ZONING BOARD OF ADJUSTMENT, PANEL C
MONDAY, SEPTEMBER 19, 2011
AGENDA

FILE NUMBER: BDA 101-080

PROJECT NAME	REGENCY ROW FENCE RE-DESIGN
SHEET TITLE	OVERALL SITE PLAN
PROJECT CODE	RI-FEN
ISSUE DATE	08.23.11
SHEET NUMBER	LO.00

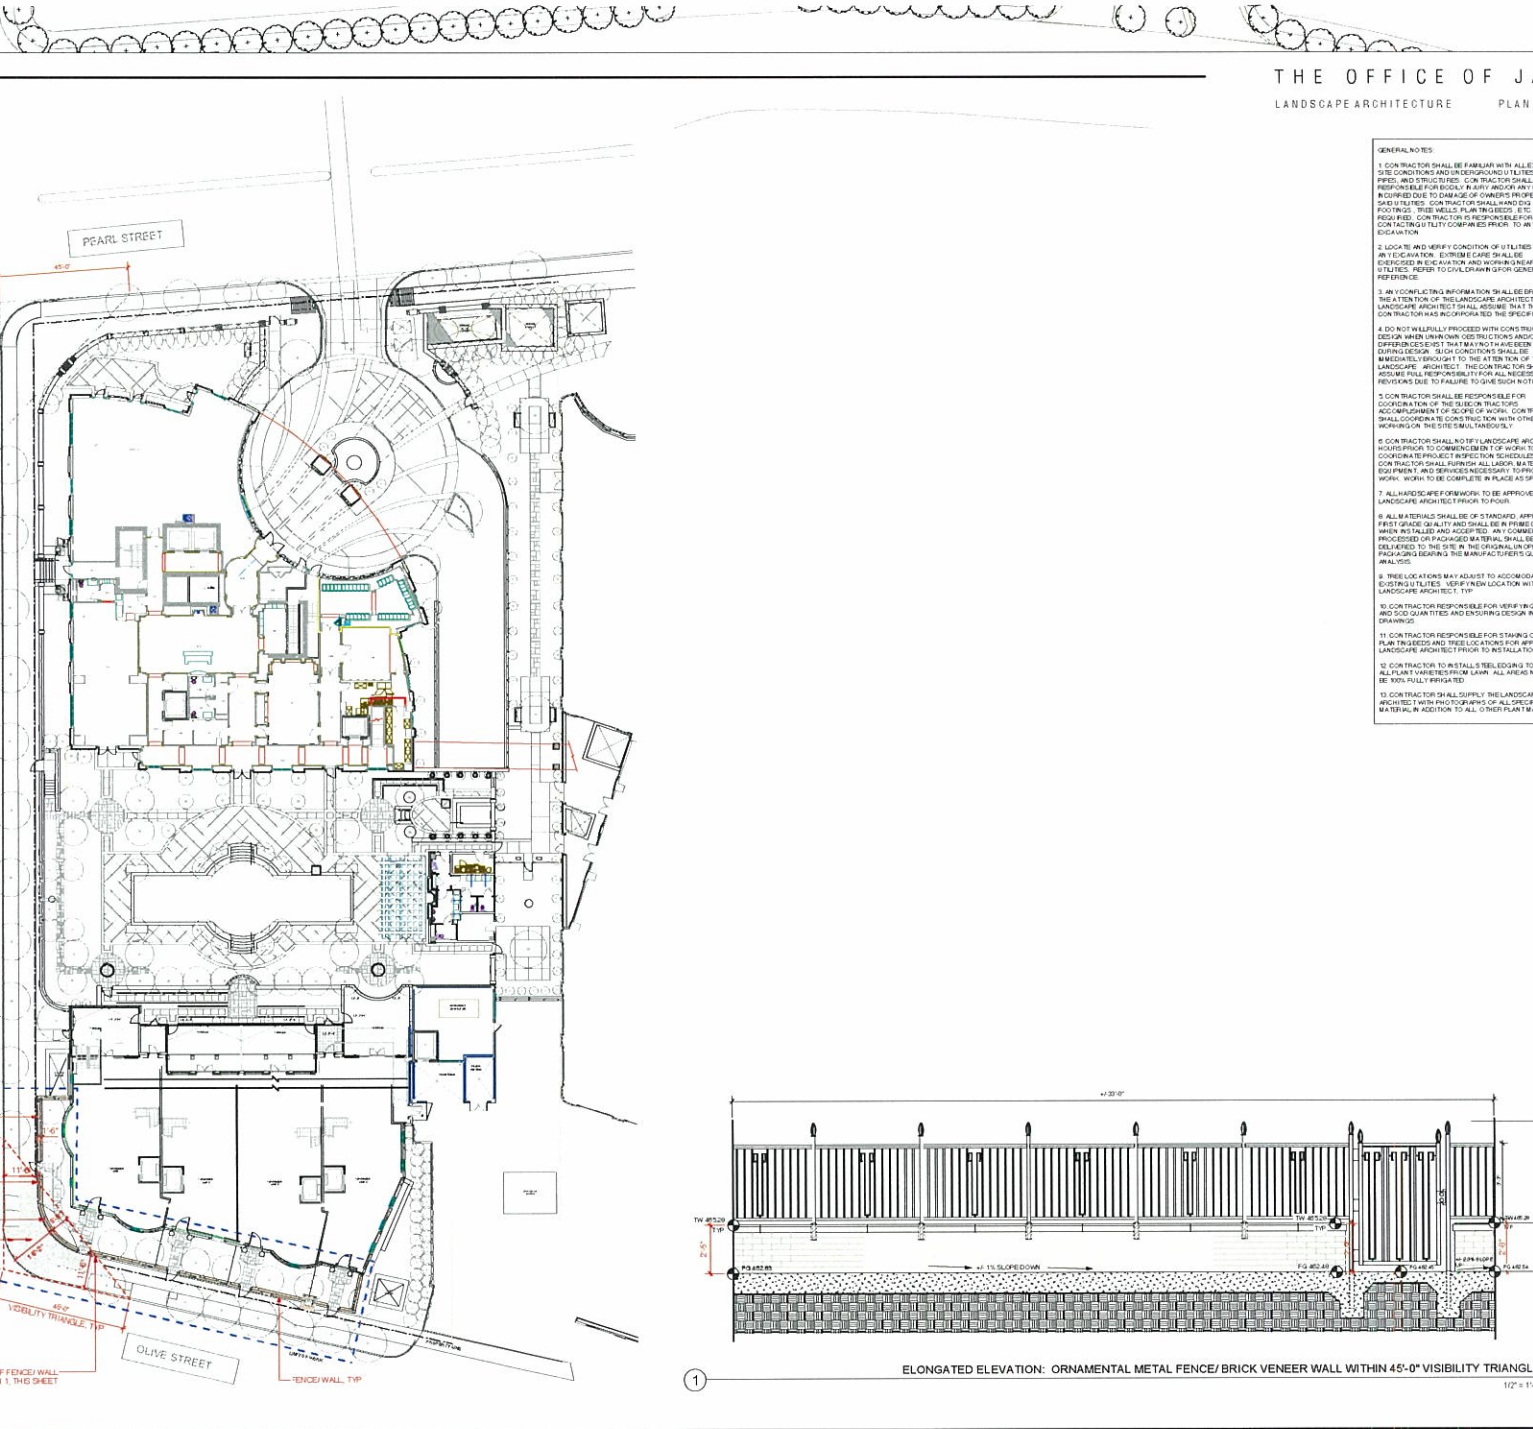
- between two and a half and eight feet in height measured from the top of the adjacent street curb (or the grade of the portion on the street adjacent to the visibility triangle).A revised site plan/elevation has been submitted that shows what appears to be an approximately 18-foot long curved fence/wall line located in the 45-foot visibility triangle at the intersection of Olive Street and Cedar Springs Road. The revised elevation indicates a three-foot three-inch high open metal fence atop a two and a half -- two-foot eight-inch high “new brick wall.”

- The Sustainable Development and Construction Department Project Engineer has conveyed that he has no objections to the request based on what has been conveyed in the applicant’s revised site plan/elevation.

- Compliance with the submitted revised site plan/elevation is required.

① ELONGATED ELEVATION: ORNAMENTAL METAL FENCE/ BRICK VENEER WALL WITHIN 45'-0" VISIBILITY TRIANGLE
 1/2" = 1'-0"

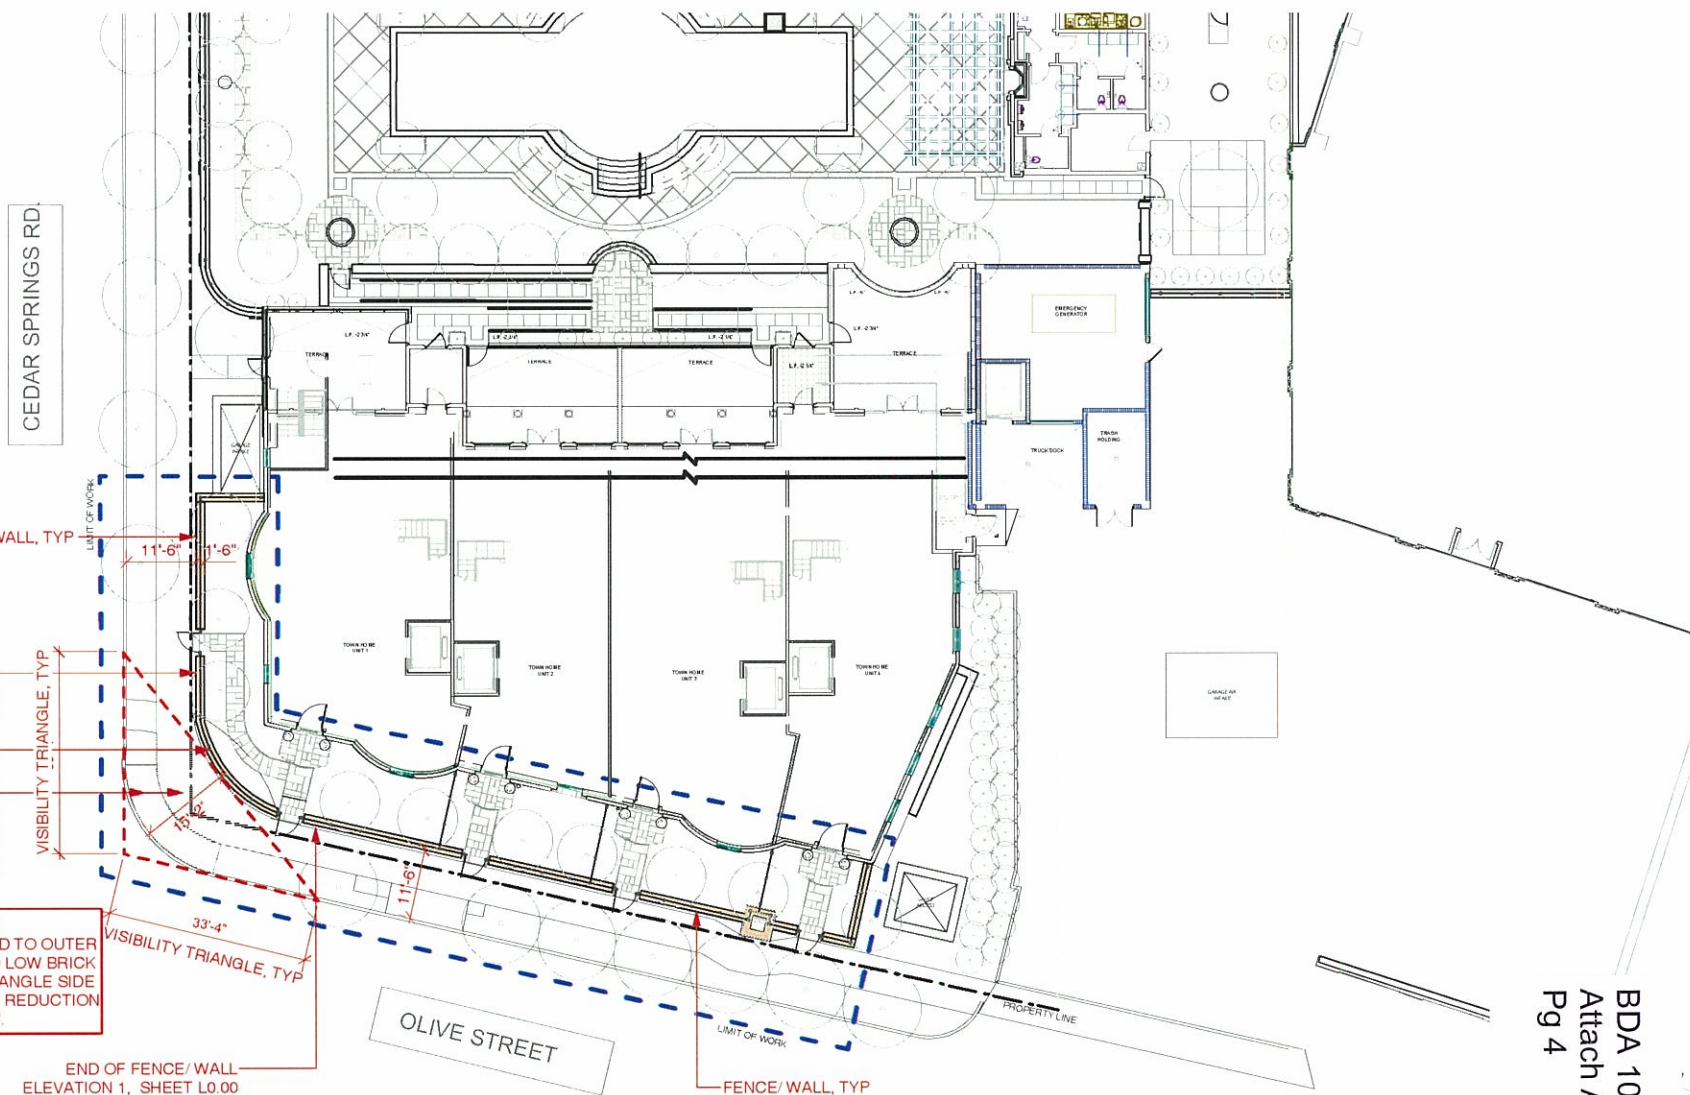
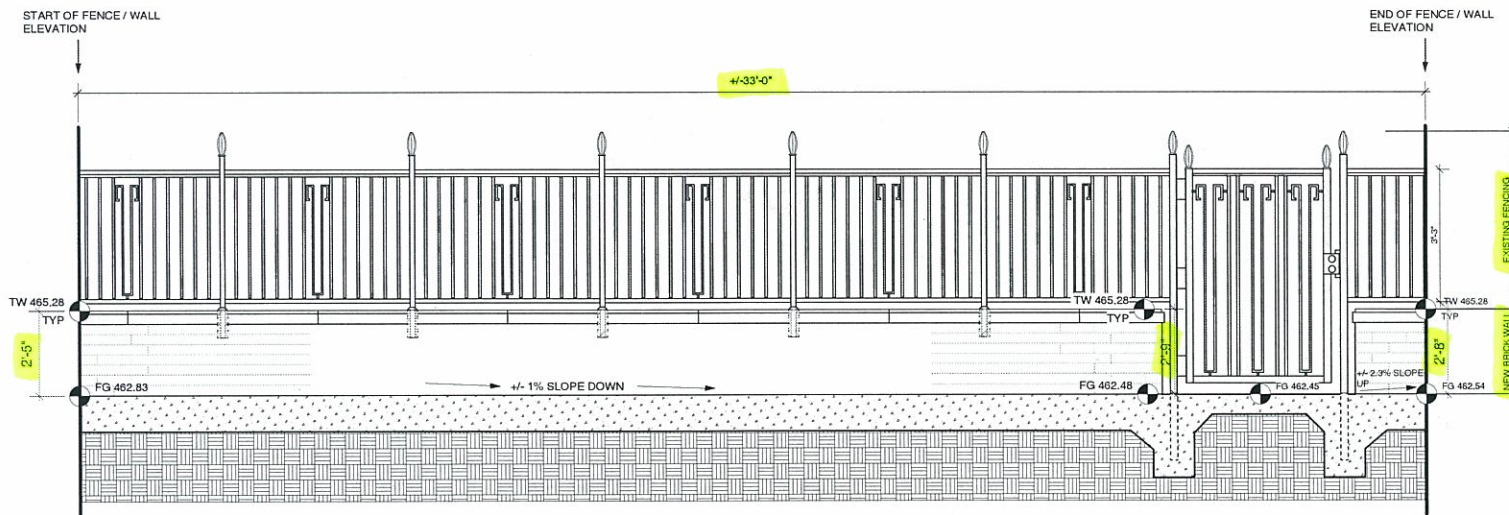
September 7, 2011: The Sustainable Development Department Project Engineer submitted a review comment sheet marked "Has no objections if certain conditions are met" commenting "Conditions: 1) Applicant will provide minimum 33 x 33 ft visibility triangle as provided instead of the 45 x 45 ft standard; 2) wall under the fence will not exceed 30" in height above top of street curb; 3) fence on top of wall will be open (wrought iron) as proposed by the applicant; and 4) area in front of wall (streetside) will be concrete or grass with no obstructions above grade."

September 9, 2011: The Sustainable Development Department Project Engineer submitted a *revised* review comment sheet marked "Has no objections if certain conditions are met." (Note that some of the comments made in this revised review comment sheet

make reference to the “applicant’s email” that is part of Attachment A in this case report). The engineer commented: “I agree to the modified conditions of the applicant’s email dated 9-8-11, 11:57 a.m. (i.e. 33” on condition 2, allow 6” wide planting strip, no more than 30” in height). See attached emails dated 9-8-11 and 9-9-11.” (The applicant conveyed in a 9-12-11 email that his submitted revised site plan/elevation addresses the concerns mentioned in what was mentioned between him and the project engineer in the 9-8-11 and 9-9-11 emails).

- Condition # 2 would limit the brick portion of the fence to 30". Our elevation drawing shows the highest portion at 2'9" (33"), due, as I understand it, to linking the fence up to a concrete garage vent further down the street and a slight slope in the frontage. Would you consider conditioning us to the elevation drawing as submitted? This would just add a 3 inches at the highest point, while other portions of the brick portion of the fence as shown are actually under 30".

- Condition # 4 would limit the area in front of the fence to concrete or grass, that is, nothing higher than grade. There will be a six inch planting strip, and instead of, or at least in addition to, grass, I think it would be good to be able to plant some seasonal color, mondo grass, etc. It seems to me this would dress up the site and the fence, and be a benefit to the adjacent owners and to the public. Would you consider allowing plantings in that strip up to a certain height (maybe even up to 30" at maturity, so as not to be in the 2 1/2 foot visibility triangle)?

- Our submitted plan shows one street tree on the Olive Street side in the triangle. This tree is already in place, and was approved by Phil Erwin when the applicant's landscape plan is approved. They would like to be able to keep this tree here, which I think is also a benefit to the look of the site and how it appears to the public, with no downside regarding traffic safety. Would you consider stipulating that this tree can remain?

Jonathan,
I'm OK with 33" on condition 2, if needed to be 30" on condition 4, and if I understand, the tree is in the 45' but not the 33' so it just needs to be trimmed clear between 30" and 8'. If you agree I can support the request with 4 modified conditions. Please let me know.
Jerry

① APPLICANT WILL PROVIDE MINIMUM OF 33 X 33 FT. VISIBILITY TRIANGLE AS PROPOSED INSTEAD OF THE 45 X 45 FT. STANDARD.

3104 San Lucas Avenue: Fenceline Elevation Drawings

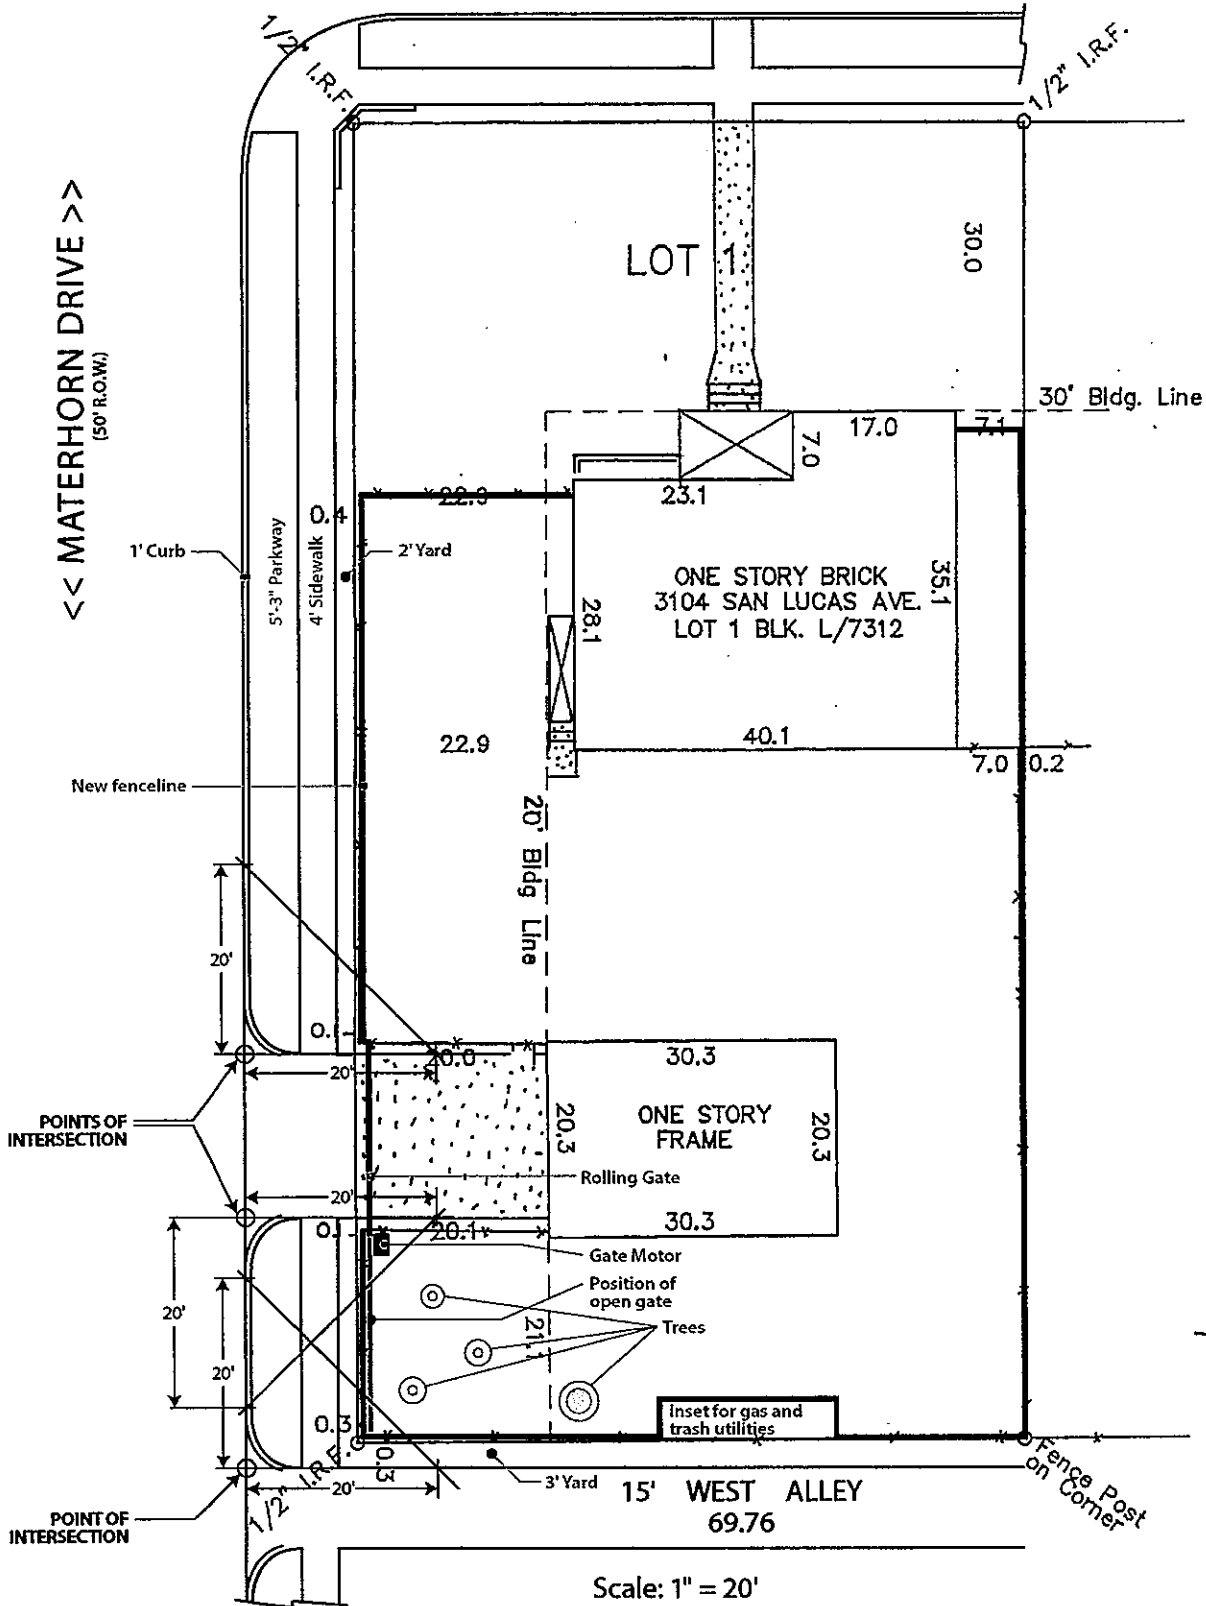
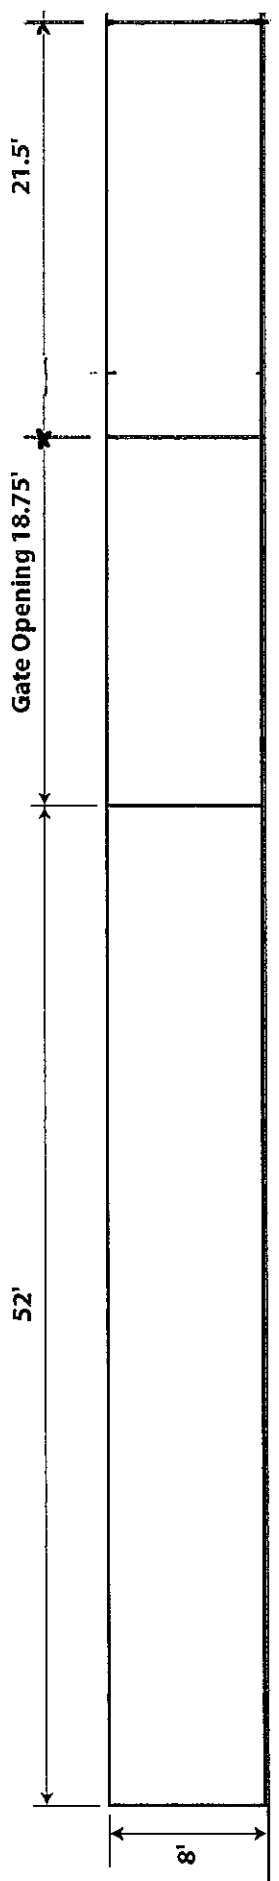
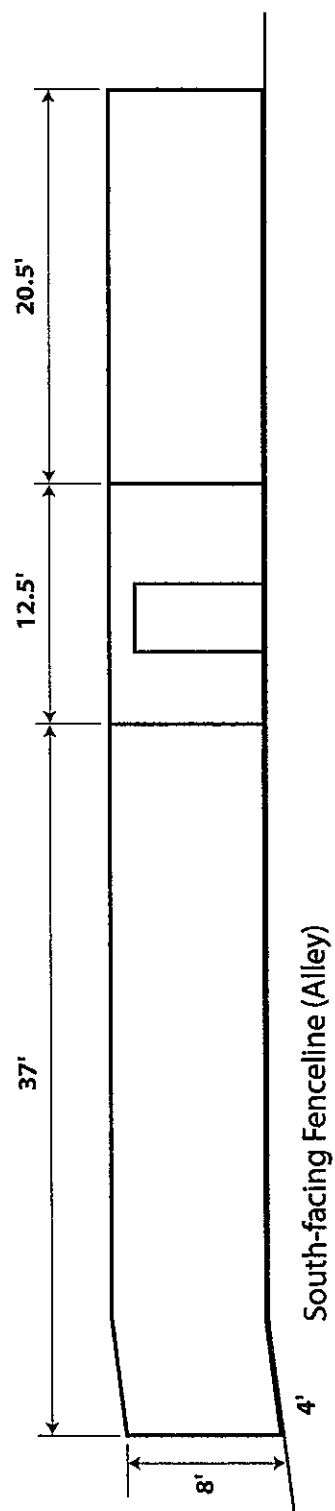
A site plan has been submitted that shows a fence (and sliding gate) located in the two 20-foot visibility triangles at the drive approach into the site from Matterhorn Drive (lengths of approximately six feet in each triangle), and in the 20-foot visibility triangle at the intersection the alley immediately south of the site at Matterhorn Drive (length of approximately five feet in this triangle). An elevation document has been submitted that represents what appears as a solid fence (no materials are denoted on the elevation) that is eight feet in height.

September 8, 2011: The Sustainable Development and Construction Department Engineering Assistant Director submitted a review comment sheet marked “Recommends that this be denied” commenting “1) Alley visibility obstruction should be denied due to pedestrian safety concerns. (Remedy exists by sliding

- The Sustainable Development and Construction Department Engineering Assistant Director submitted a review comment sheet marked “Recommends that this be denied” commenting “1) Alley visibility obstruction should be denied due to pedestrian safety concerns. (Remedy exists by sliding gate in other direction); and 2) No objections to driveway visibility triangles.”
